REV2 REFERENCE / REDESIGN IN PROGRESS

22 September 2026: the current print order is N1 nose only.

The following pages retain the old Rev2 design for reference. They are not the current full-aircraft manufacturing instructions. Their original page numbers remain unchanged; this notice is an additional page.

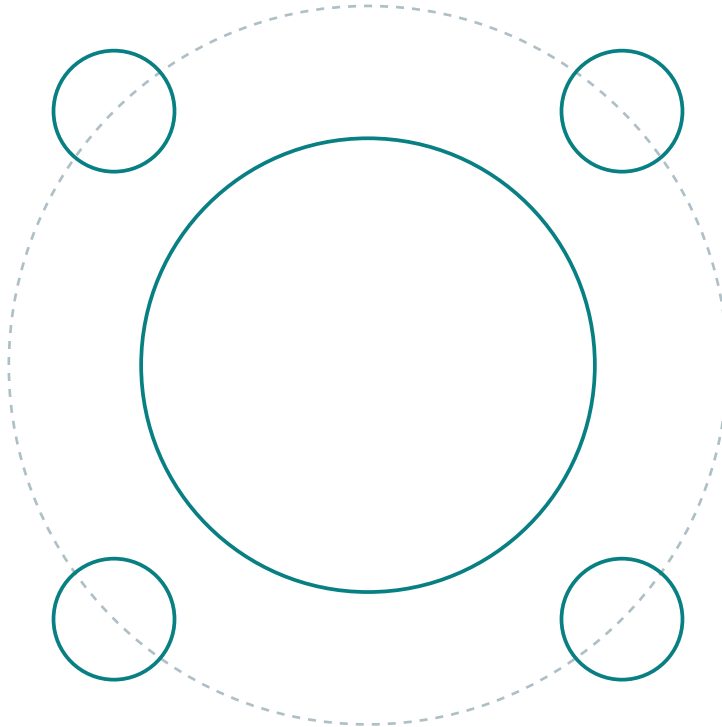
Landing gear and steering system; the old 42-piece print order; A59 cover screw holes, columns, spacers and shaped washers; the large nose pitot-access notch. Do not fabricate these from the old instructions.

N1 restores the original upper nose shell. It uses a proposed simple ledge/tape attachment and a probe passage drilled to actual hardware during assembly. It retains the original rear mating envelope.

Use Manufacturing/Nose_Print_N1/A59_Nose_N1_mm.stl and Nose_N1_Print_Guide.pdf. Quantity one, millimetres, 100%.
